4 PROJECT ALTERNATIVES

4.1 MINING

Figure 4.1 Existing and proposed nuclear power reactors

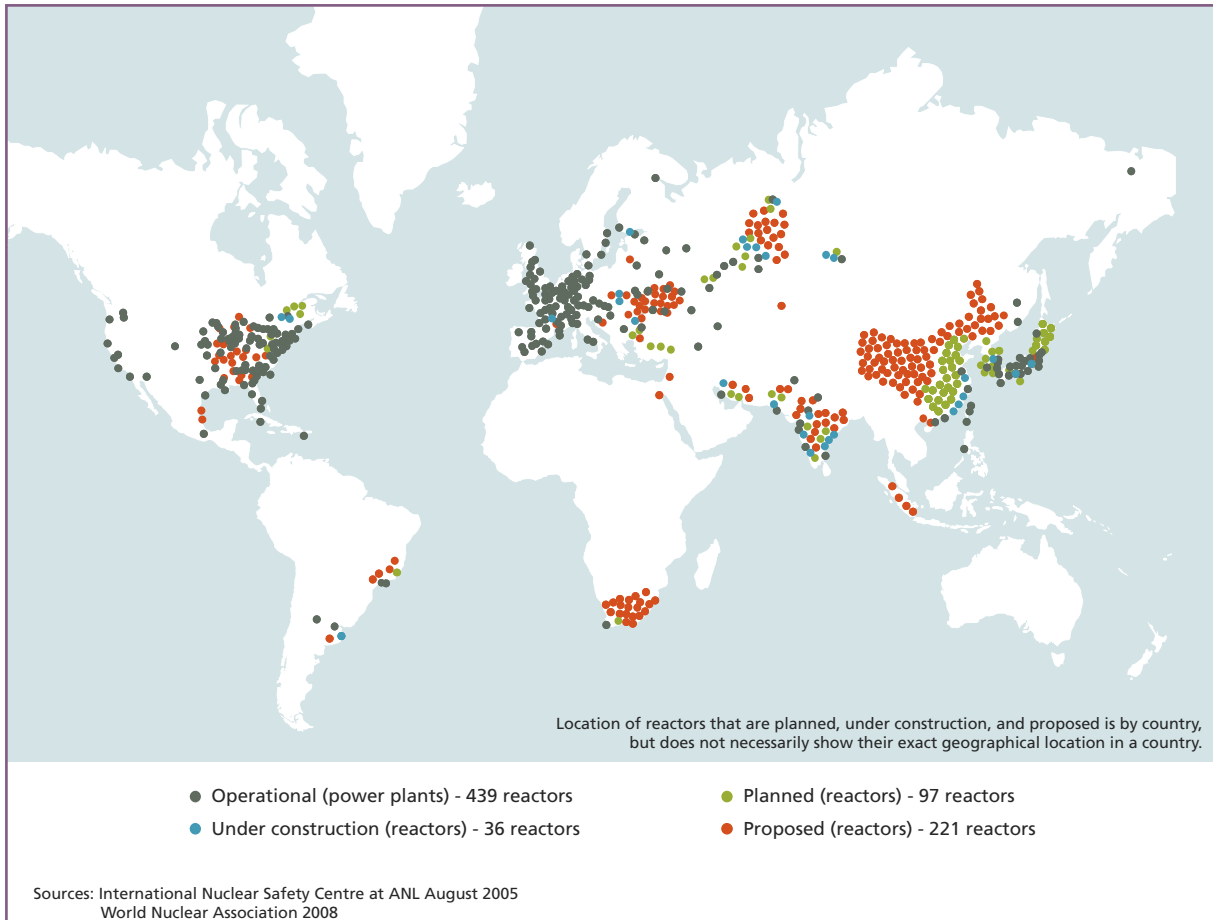
The Draft EIS states that mining at the proposed scale is the preferred option and maximises the return on investment. Submissions have questioned the quantity of uranium to be extracted and processed on the basis that the uranium market is not predictable or stable.

With respect to uranium oxide, Section 3.2.3 of the Draft EIS detailed the current and long-term forecasts for market demand and supply, with the data showing a strong long-term upward trend. Figure 3.11, reproduced here as Figure 4.1, illustrated the planned growth from 439 nuclear reactors currently in operation worldwide to 793 expected by 2030. The resulting demand chart for uranium oxide through to 2030 was shown in Figure 3.10, reproduced here as Figure 4.2.

The quantity of uranium oxide required to meet the 2008 global demand was 64,200 tonnes. The total supply from mines in that same year was 41,279 tonnes, with Olympic Dam the third largest uranium oxide producer in the world, contributing about 4,000 tonnes. The supply and demand gap from uranium mine production, even without the additional 354 nuclear reactors, was 22,921 tonnes. Olympic Dam is proposing an increase of 15,000 tonnes of uranium oxide per year when at full operating capacity, making an annual total production of 19,000 tonnes. With the additional nuclear reactors expected by 2030, about 92,000 tonnes per annum (tpa) of uranium oxide would be required. Therefore, the additional 15,000 tpa from Olympic Dam would be contributing to a demand gap of 50,721 tpa.

Figure 4.5 Desalination plant location options

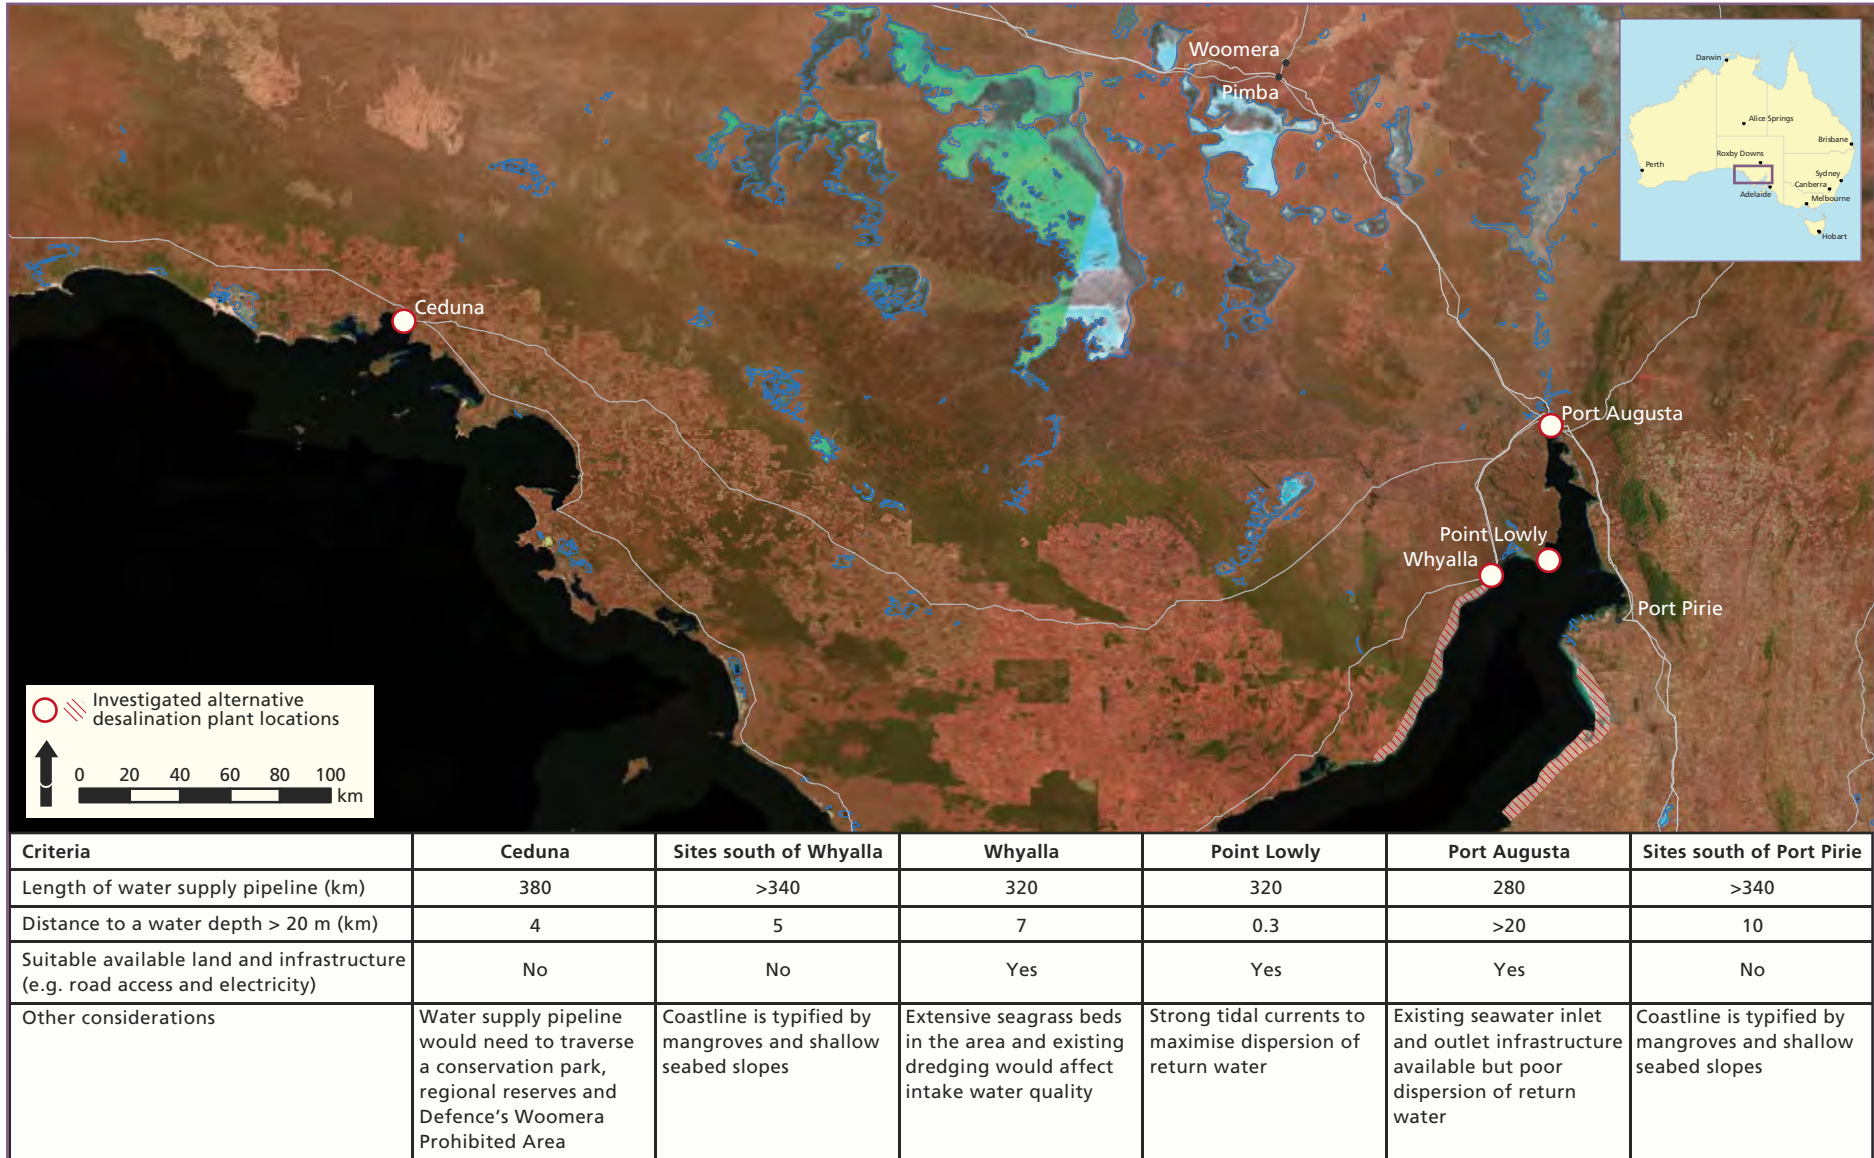
Further justification was sought for locating the proposed desalination plant at Point Lowly, rather than on the west coast of Eyre Peninsula and the Far West Coast. A common reason for seeking justification and preferring such a location was that return water could be discharged directly into the ocean and that additional water could be made available for public consumption by local communities to supplement the existing SA Water supply.

BHP Billiton used a number of criteria to assess the suitability of proposed locations for the desalination plant. Figure 4.3 of the Draft EIS, repeated here as Figure 4.5, showed the location of the six sites investigated, at Point Lowly, Port Augusta, Whyalla, south of Whyalla, south of Port Pirie and Ceduna (on the Far West Coast).

The assessment against each criterion for each of the six sites is also presented in Figure 4.5, highlighting the reasons for selecting Point Lowly as the preferred location and rejecting the other five locations assessed in the Draft EIS, including Ceduna. BHP Billiton acknowledges that submissions received on the Draft EIS have suggested that west coast locations other than Ceduna would be suitable for the Olympic Dam desalination plant; therefore these have been considered further (see Figure 4.6).

Figure 4.13 SA Water infrastructure on Eyre Peninsula

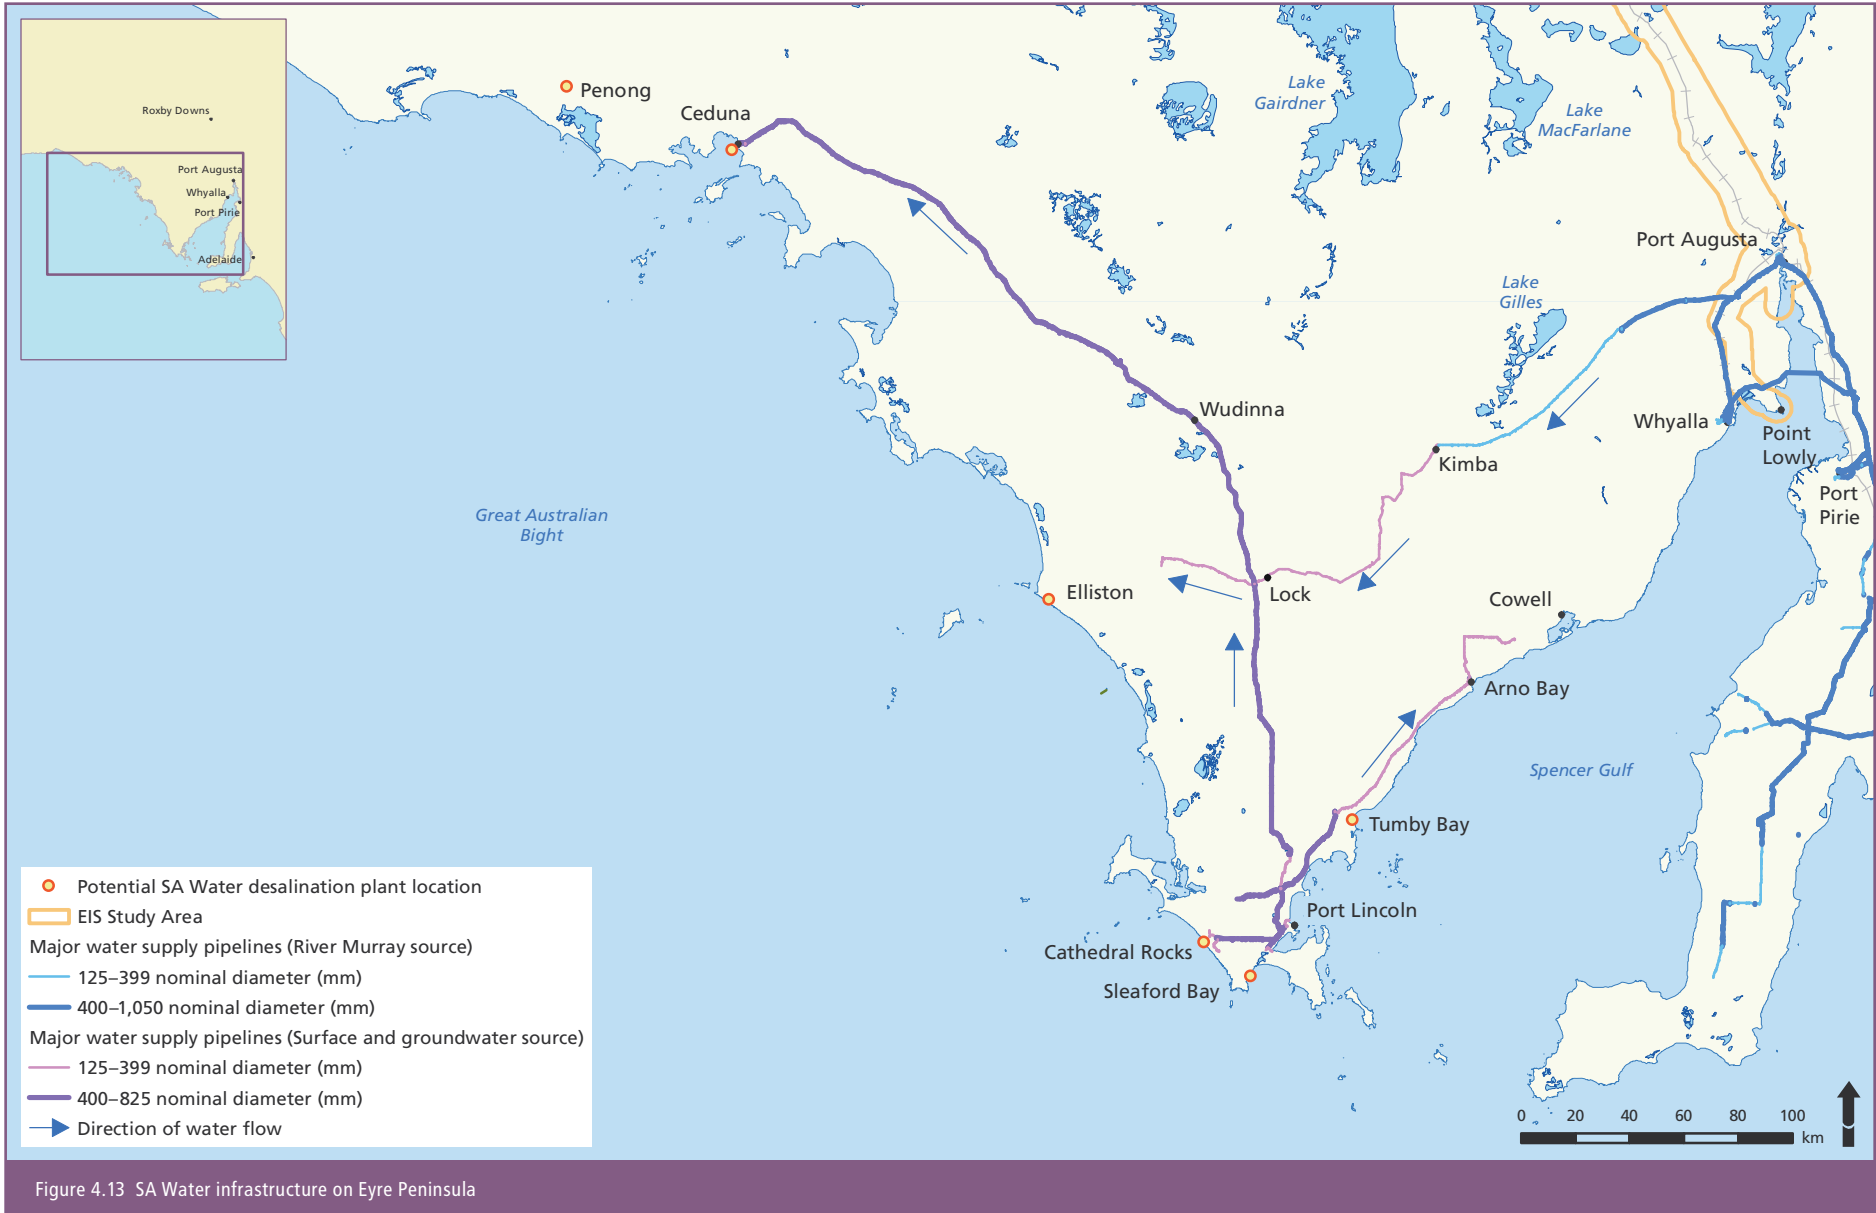
Submissions requested water from the desalination plant to be provided to local communities.

The existing SA Water network (see Figure 4.13) supplies River Murray water to Eyre Peninsula through pipelines via Port Augusta (underground) and Port Broughton (undersea), which continue via Iron Knob to Kimba and Lock (SA Water 2010a). The majority of Eyre Peninsula is supplied by a network of pipelines that originate in Port Lincoln and pump groundwater north towards Lock and north-east towards Cleve; and from Lock north-west towards Ceduna (SA Water 2008; see Figure 4.13).

Point Lowly is well located to provide water to supplement existing SA Water supplies, as it is close to the SA Water network and complements the flow direction of the existing system. Locating the plant at Ceduna or another location on the west coast of Eyre Peninsula would require either a reversal of the current flow direction in the north-western portion of the SA Water network, or the construction of an additional pipeline to supply areas south-east of Ceduna (SA Water 2008). In addition, the capacity of the existing SA Water network to pump in this direction may be insufficient for the volumes of water required due to the small (825 mm or less) pipeline diameters in this area (see Figure 4.13).

Figure 4.14 Alternative energy resources in South Australia

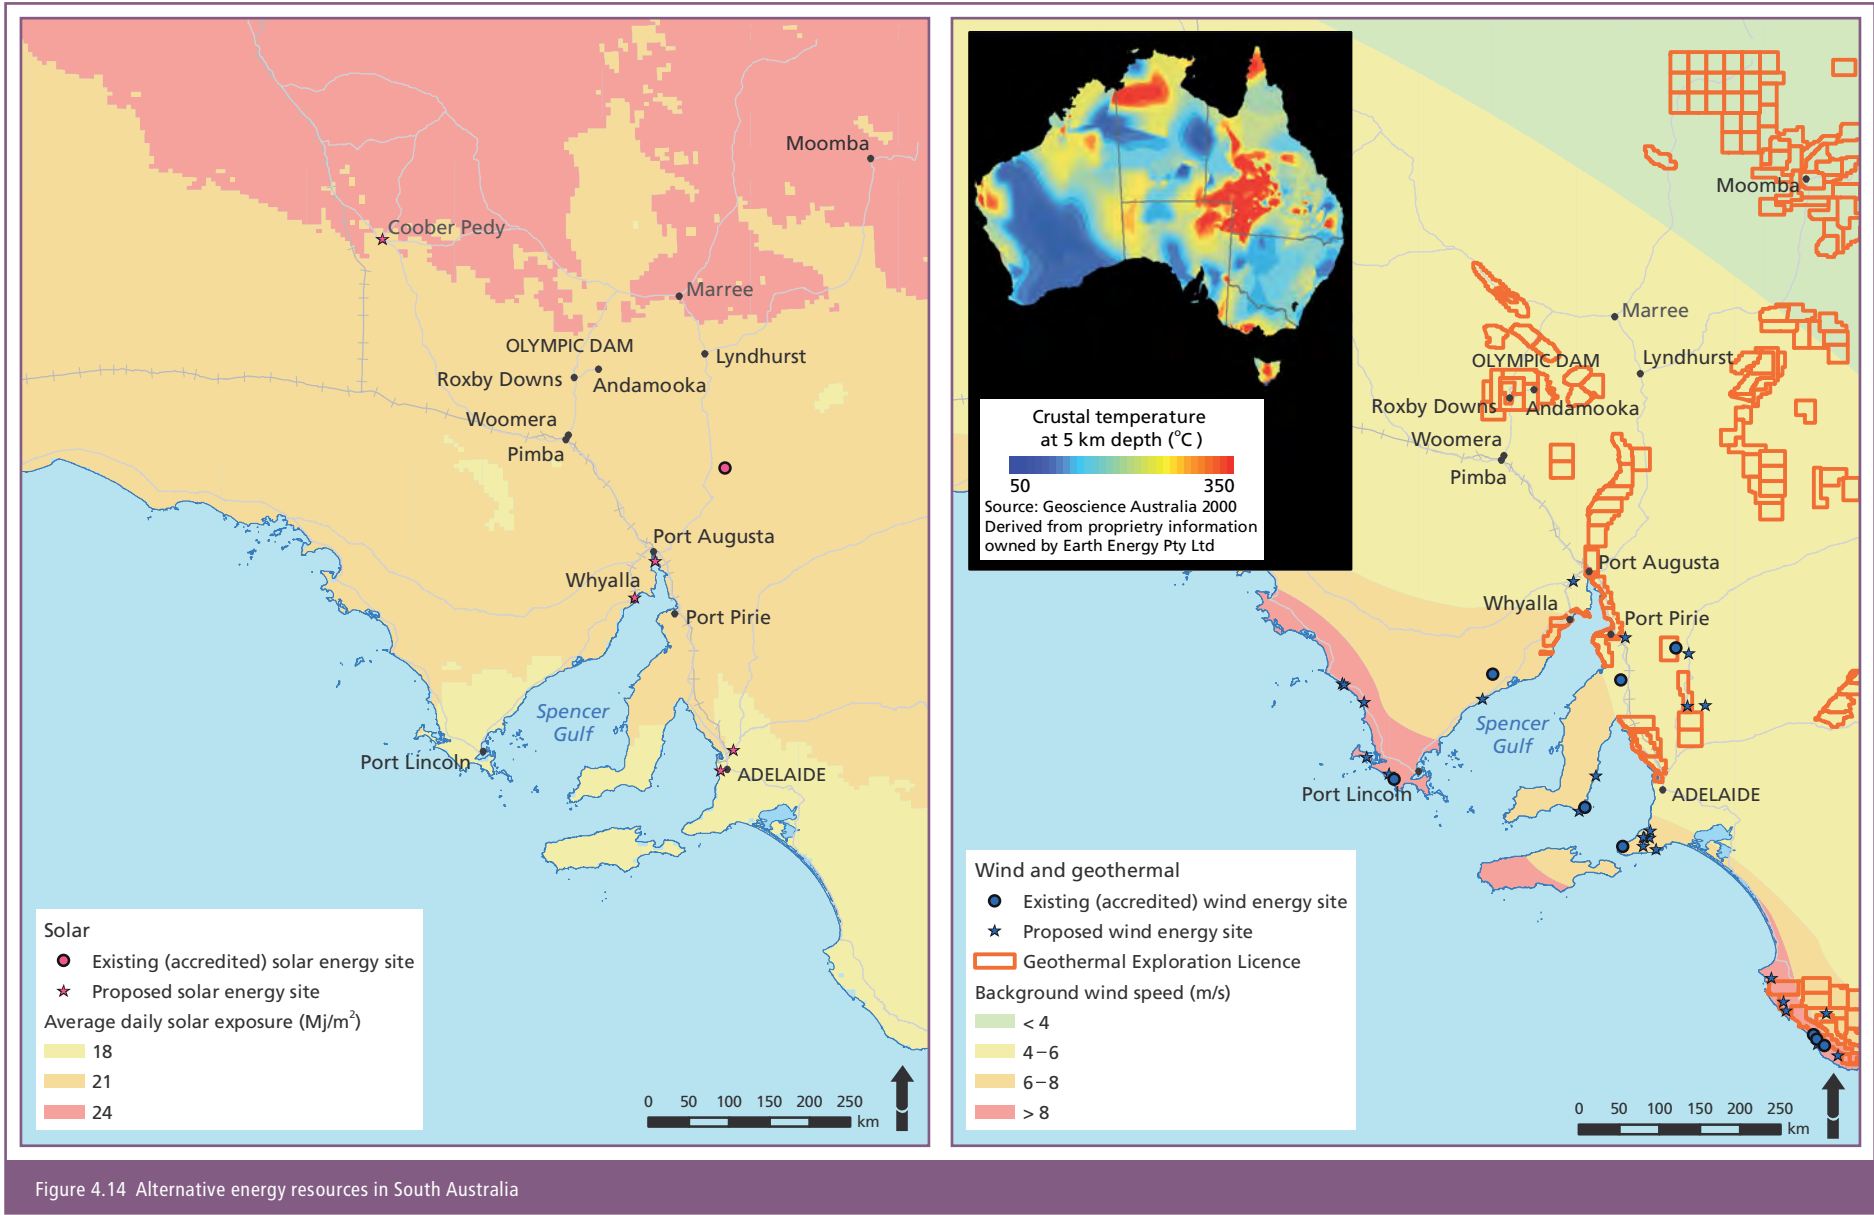
BHP Billiton's commitment to power the desalination plant with renewable energy was commended in several submissions. It was requested that contractual links be developed to tie the supply of this electricity to local providers. It was also suggested in the submissions that renewable energy generation sites co-located with the desalination plant would be the most favourable outcome for powering the plant.

Figure 4.6 of the Draft EIS, reproduced here as Figure 4.14, provided an indication of the solar, wind and geothermal energy potential of sites based on just some of these factors.

From the discussion above, it can be concluded that obtaining renewable energy from the NEM rather than a co-located generation facility is the optimum method of ensuring a stable baseload energy supply for the desalination plant while still using a renewable energy source.
